**CITY OF ROCKVILLE HISTORIC DISTRICT COMMISSION
STAFF REPORT**

APPLICATION: HDC03-0252

REQUEST: The Applicant requests a Certificate of Approval to screen in and roof an existing rear deck (approximately 280 square feet) that is on the southwest corner of the house and is not visible from any public right-of-way.

Views of rear façade of 11 Wall Street with existing deck

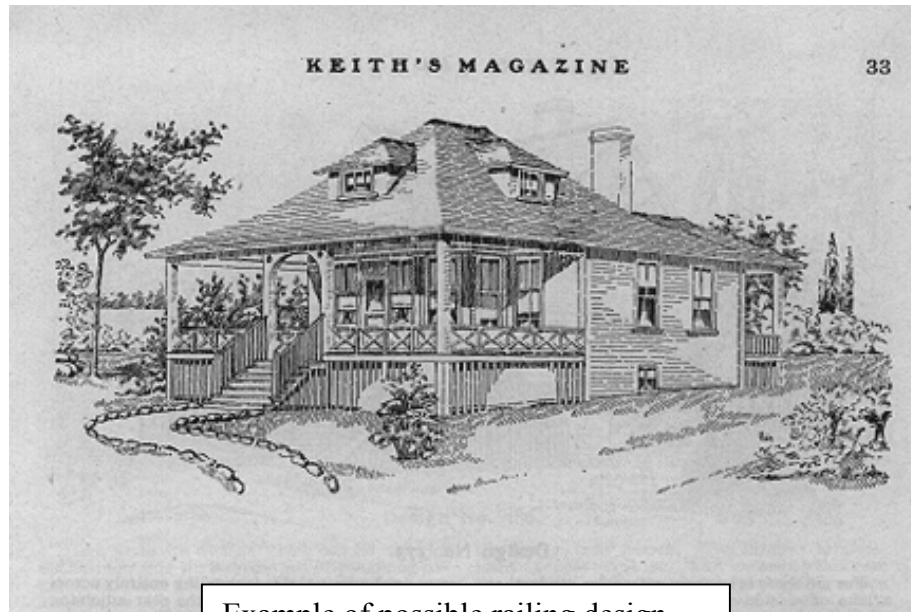
The dimensions of the screened porch (approximately 14 feet x 20 feet) will be the same as those of the existing deck. The shed roof on the porch will have the same height and pitch as the roof on the adjoining family room addition.

The Applicant proposes to install lattice below the floor level of the porch as well as above floor level to the railing. Lattice is more typically used as a screening material beneath a porch floor. Wooden pickets or a simple design similar to that shown below may be more appropriate for the railing. The railing height must be 36 inches from the floor.

STAFF RECOMMENDATION: Staff recommends that the HDC approve HDC2003-0252 to screen in an existing rear deck. Staff recommends replacing the lattice above the floor level with pickets or another more traditional design.
